Change Notice No.	Notification date	Implementation date
CN/A/25/004 - Rev. No.: 02	April 10, 2025	May 10, 2025

**Subject :Minimization of EPE (Expanded Polyethylene) used as protective packaging in the packing of mdi Single Use Assemblies/Systems.**

**Scope :This change will affect the packaging of gamma sterilized mdi Single Use Assemblies/Systems, part number is mentioned below (where # can be any numeral or alphabet):**

#### **Existing Packaging**

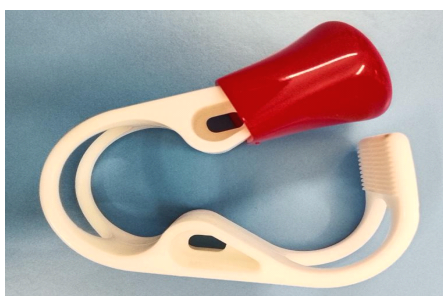
The EPE used in packaging of single use assemblies is opaque in nature and it is difficult to inspect the components during final inspection of packed assemblies. To facilitate the visual inspection and to improve the transparency of packed single use assemblies/systems, the usage of protective packaging i.e. EPE shall be minimized.

- Use of EPE as a complete over wrap shall be discontinued to facilitate the final visual inspection of packed assemblies.

- In order to prevent any damage to primary packaging pouch, sharp edges of components such as locking ties, oetiker clamps and pinch clamp shall be covered with red caps and tie guards/oetiker guards (as shown in pictures below).

- The large components such as capsule filters, threaded clamps etc. shall be covered with EPE.
- To prevent the sticking of assembly with the packaging pouch (in absence of EPE wrap), the same shall be wrapped in transparent LDPE film prior to primary packaging.
